IEEE 802.3bz 2.5G/5G Impedance Balance Specification

March 14th 2016

Radiated Emission: 10G vs. 2.5G Magnetic Comparison

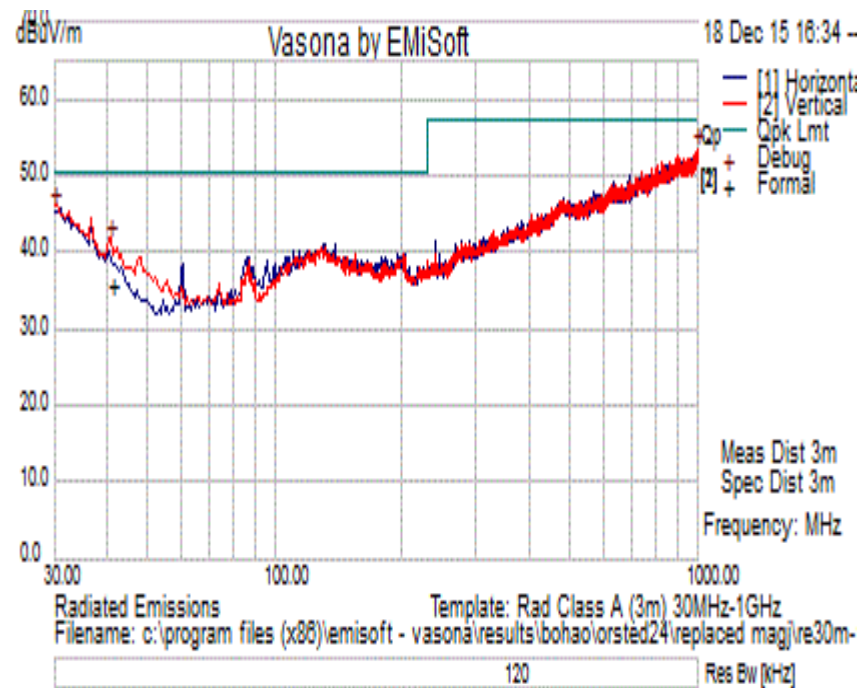
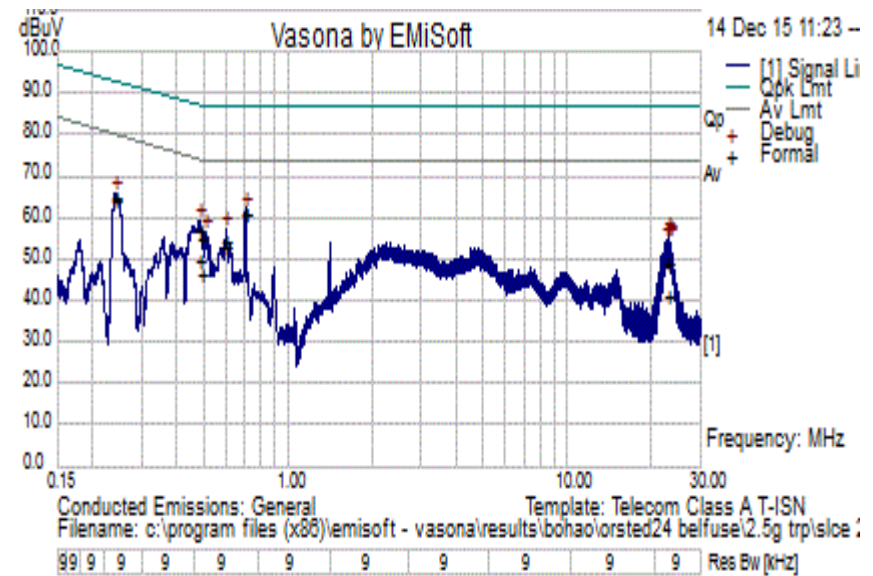
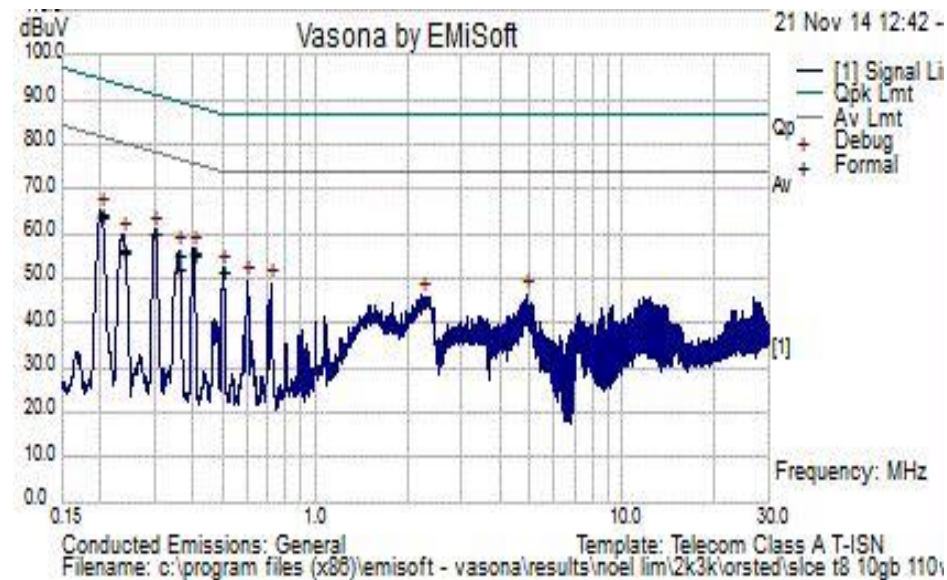
10G plot with 10G Magnetic/ 3m Cat 6a
Worst Emission at ~ 41 MHz with **4dB**
margin

2.5G plot with 2.5G Magnetic/2m Cat5e
Worst emission at ~41 MHz with **14dB**
margin

10G plot with 10G Magnetic/3m Cat6a
 Worst Emission at ~ 0.2 MHz with
17dB margin

2.5G plot with 2.5G Magnetic/3m Cat5e
 Worst emission at ~0.2 MHz with **12dB**
 margin
